CITY OF NAPOLEON - BUILDING DEPARTMENT

RESIDENTIAL PLAN CORRECTION SHEET

ADDENDUM TO Permit No. 01568
Owner JAMES ZUMPELDE
Contractor SELF
Location 226 E. WASHINGTON

subject GARAGE @ 226 E. WASH.

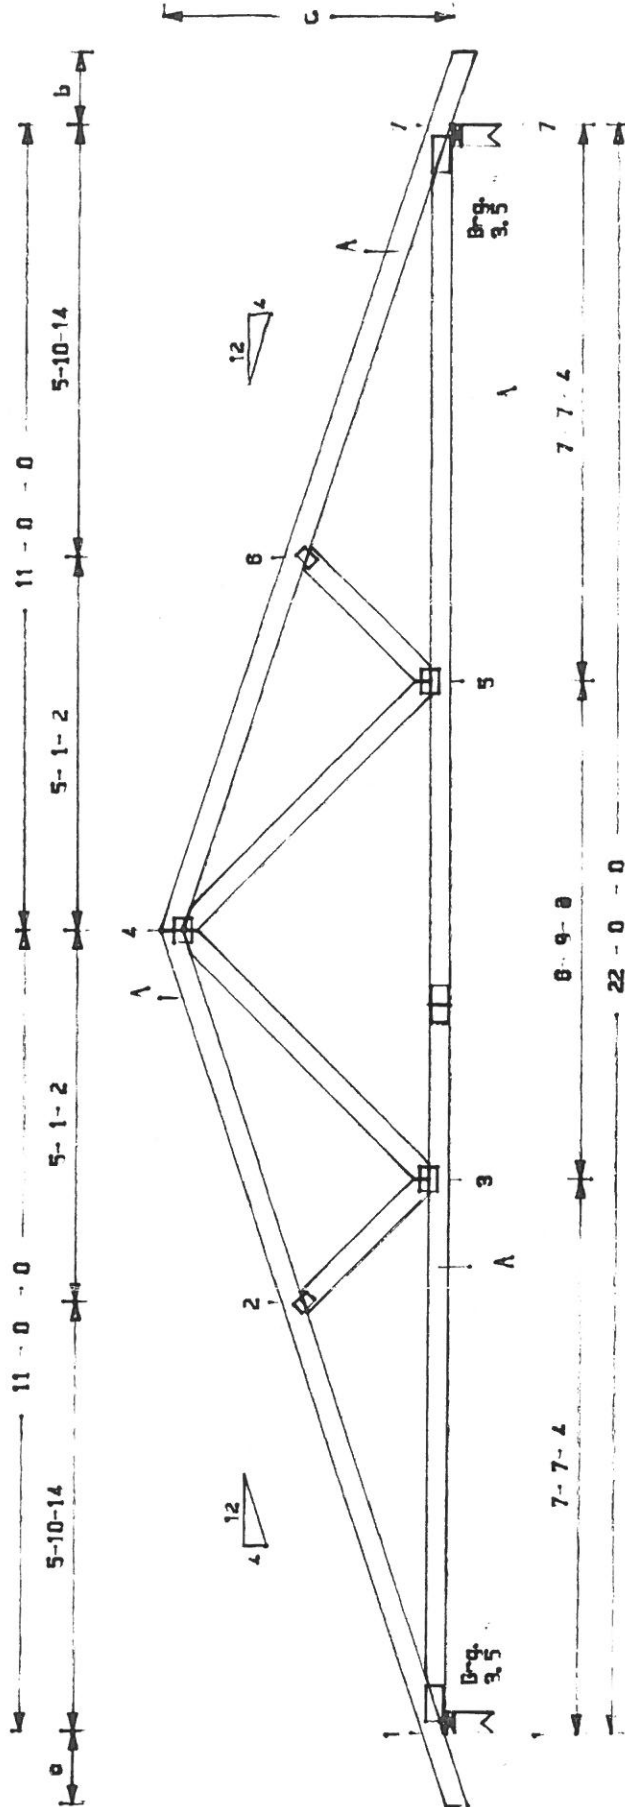
TRUSSES NOT AS SHOWN ON TROSS DIAGRAM.											
	Trusses meet Min. Sds, <i>7/19 BD</i>

THE TRUSSES YOU HAVE SUBMITTED

DO NOT MEET THE MIN BOT. CORD

LOADING REQUIREMENTS OF C.A.B.O.

MIN REQ. 10# P.S.F. LIVE + 10# P.S.F. DEAD.

TOTAL 20# P.S.F. YOU HAVE 2. OPTIONS, EITHER

REPLACE THE TRUSSES WITH ONES THAT WILL

THE CODE OR STRENGTHEN THE

TRUSS AS DIRECTED BY THE MANUFACTURER,

TO SUPPORT THE REQUIRED LOADS.

I NOTE THAT THE TRUSSES YOU INSTALLED DO NOT
MATCH THE TRUSS DIAGRAM YOU SUBMITTED. SEE
ATTACHED COPY. RESUBMIT A TRUSS DIAGRAM FOR
THE TRUSSES INSTALLED.

DESIGN CRITERIA TPI - 78		DESCRIPTION KINGPOST W/DIAG.		DRAWN BY	
SPAN VARIABLE		REMARKS		ENGINEERED BY	
PITCH / DEPTH 4/12				CHECKED BY	
DATE		NO. REVISIONS		BY	
INTER-LOCK STEEL COMPANY 3678 East State Street Sharon, Pennsylvania 16146				DRAWING NO. 2-K/D-47-15-4

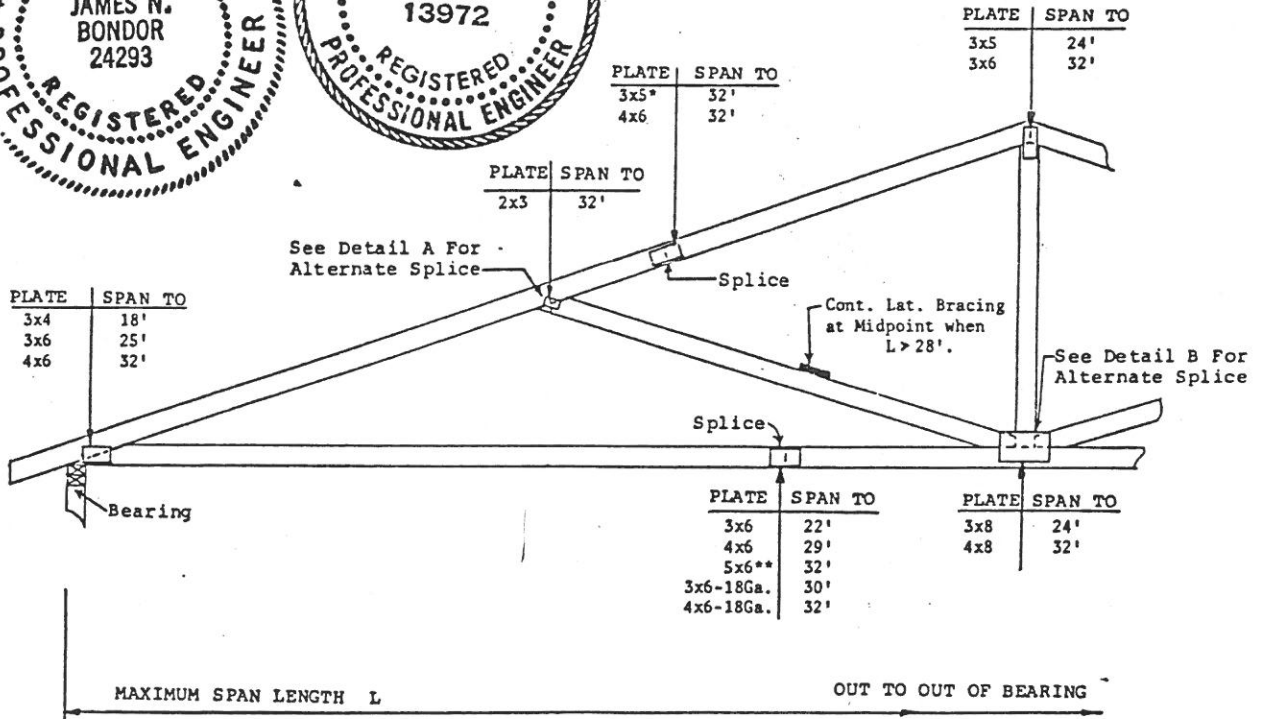
I NOTE THAT THE TRUSSES YOU INSTALLED DO NOT
MATCH THE TRUSS DIAGRAM YOU SUBMITTED. SEE
ATTACHED COPY. RESUBMIT A TRUSS DIAGRAM FOR
THE TRUSSES INSTALLED.
